**RE:** **Application for a Preliminary Plat**  
**Parcel ID: 2433-144-0002-000-3**

**STAFF REPORT**

**RE:** Rezoning, Site Plan, and Subdivision – Oleander Oaks  
Technical Review Project # 21-43900001 & 21-09000001

**RE : Oleander Oaks Planned Development and Preliminary Plat  
TRC No. 21-43900001 & TRC No. 21-09000001**

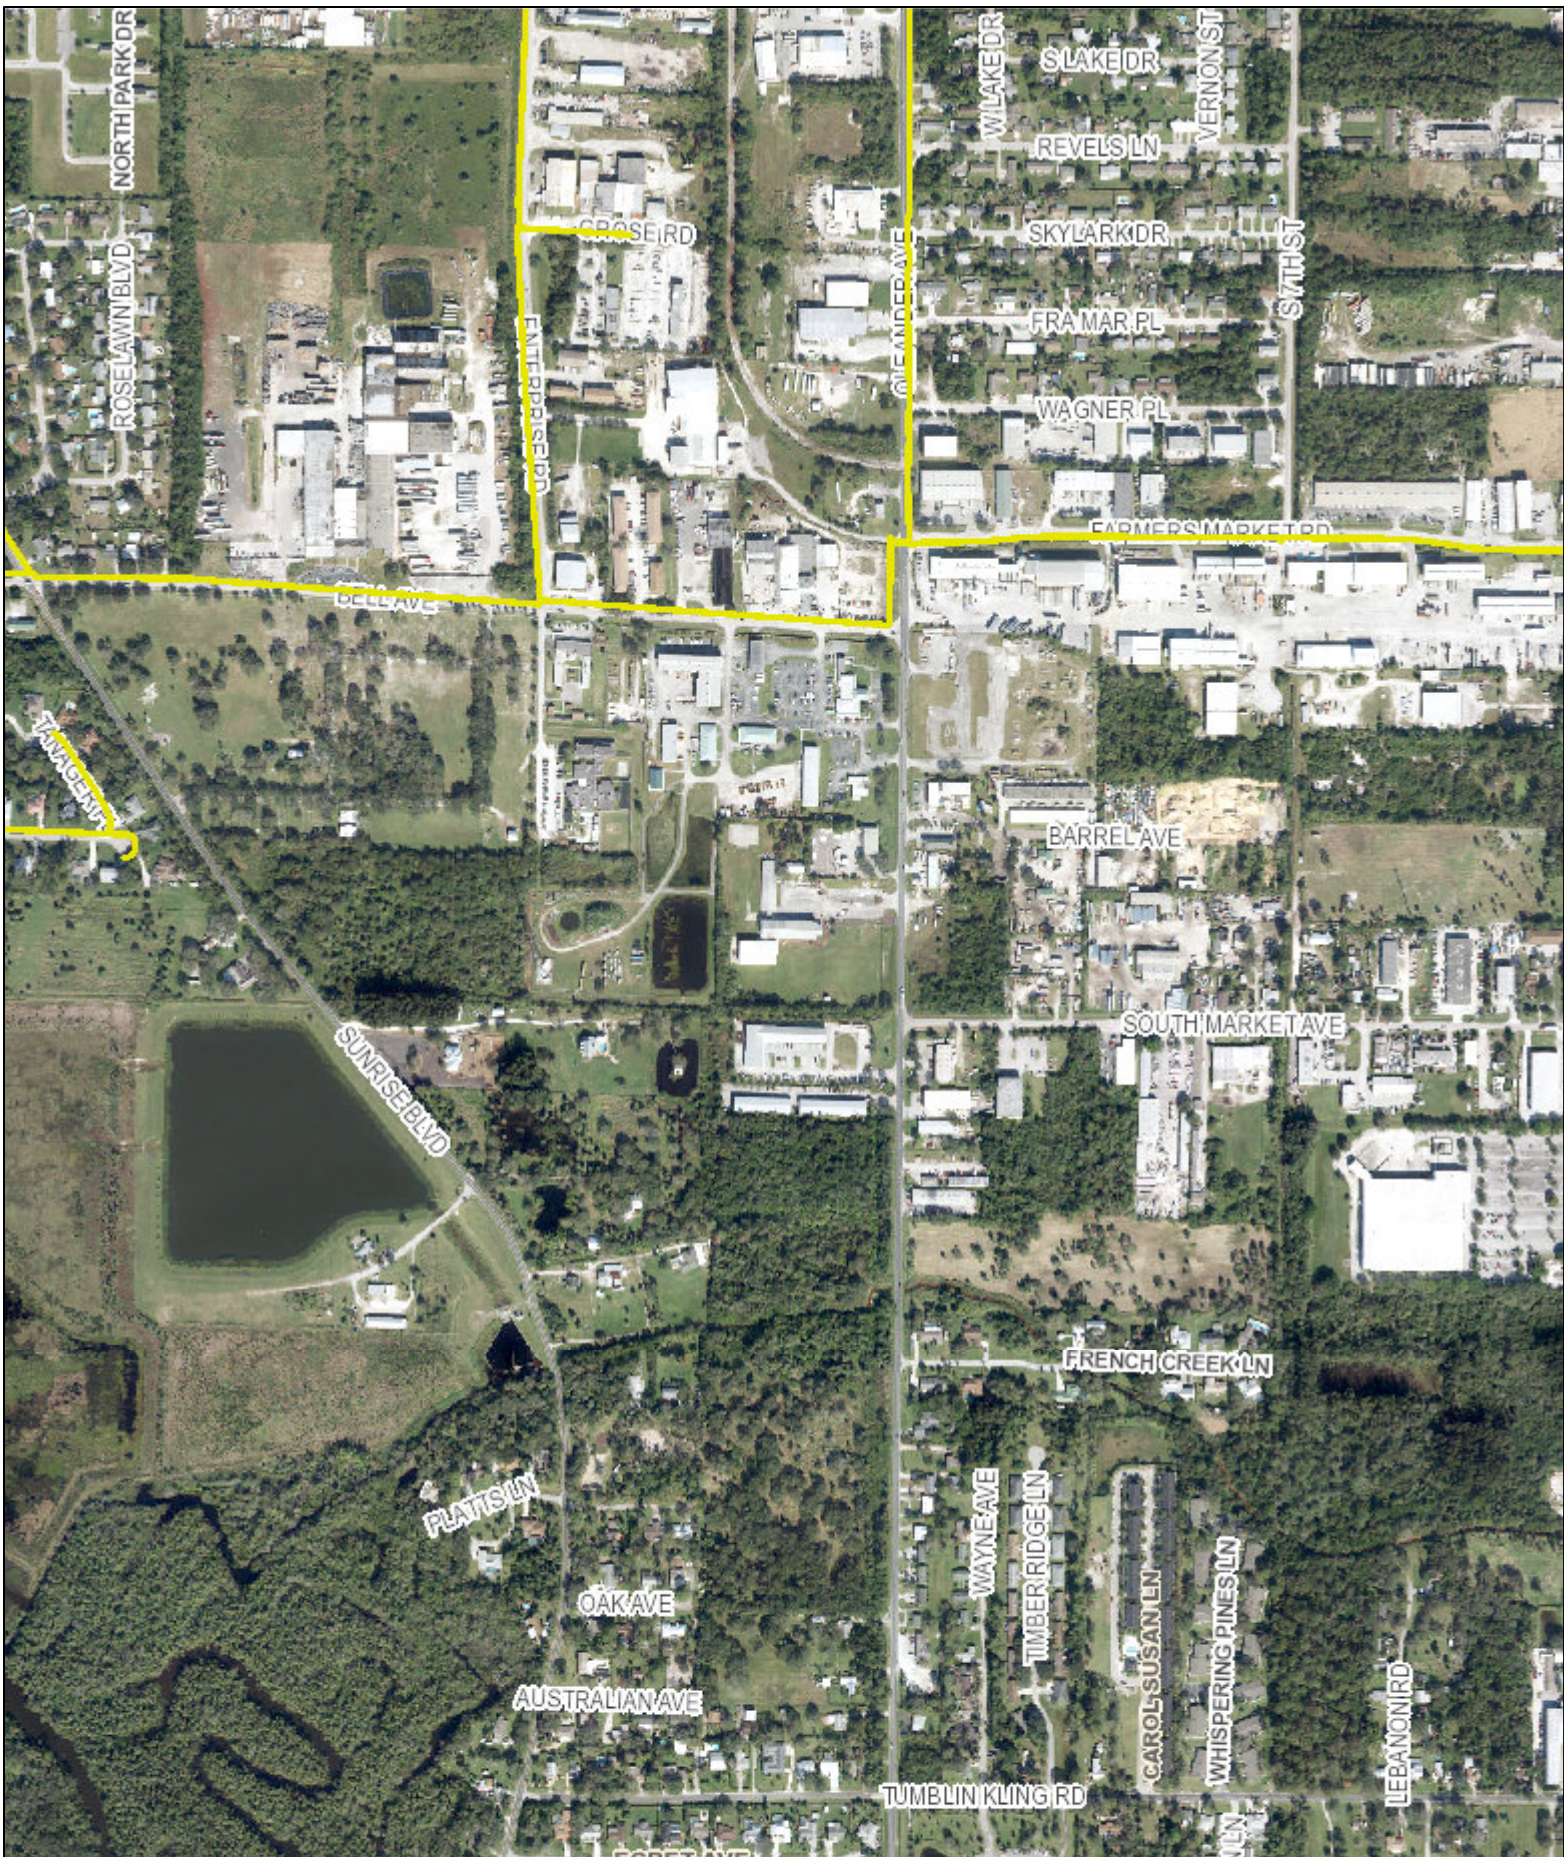
FPUA Electric & Gas Engineering: Electric - The property is not in the FPUA electric service area. Located in FPL service area. Gas – Service is available to the site (From the NW corner of Oleander Avenue and Bell Avenue). Please provide a copy of the gas riser diagram with the anticipated load (if developer is interested in natural gas service to the propose site). For more information and incentive available, please contact Ana Johnson.

FPUA will require a utility easement for all propose FPUA facilities. Please find attached a copy of the FPUA GIS map (Gas).
